Access Compliance Report

Public Rights-of-Way

(Curb Ramps)

Intersection ID: 9217	Main Street: BROWNS_AV	Cross Street: FREEDOM_DR	Location: S
ADA ID: C7219F3D6853	Ramp Type: BlendTrans1	Initial Pass/Fail: Fail	Overall Compliance: No
Severity Score: 8.75			
Codes/Mitigation Info/Possible Solution		Field Measurements/Component Compliance

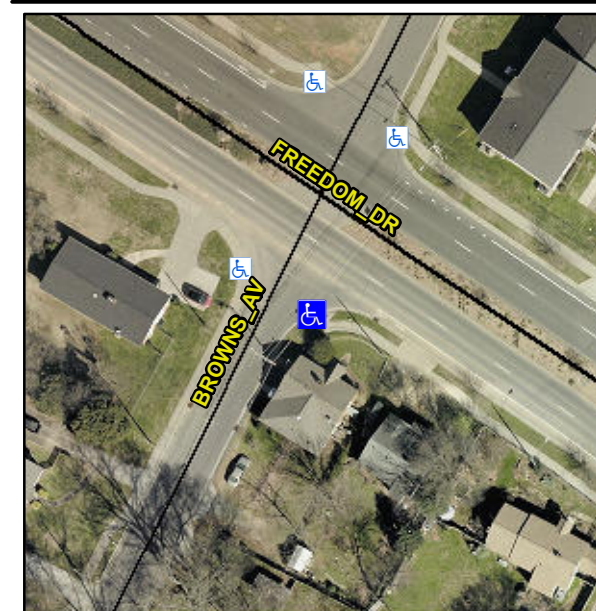
Remove & Replace Curb Ramp With Two New Directional Ramps or Equivalent.

R304.5.1
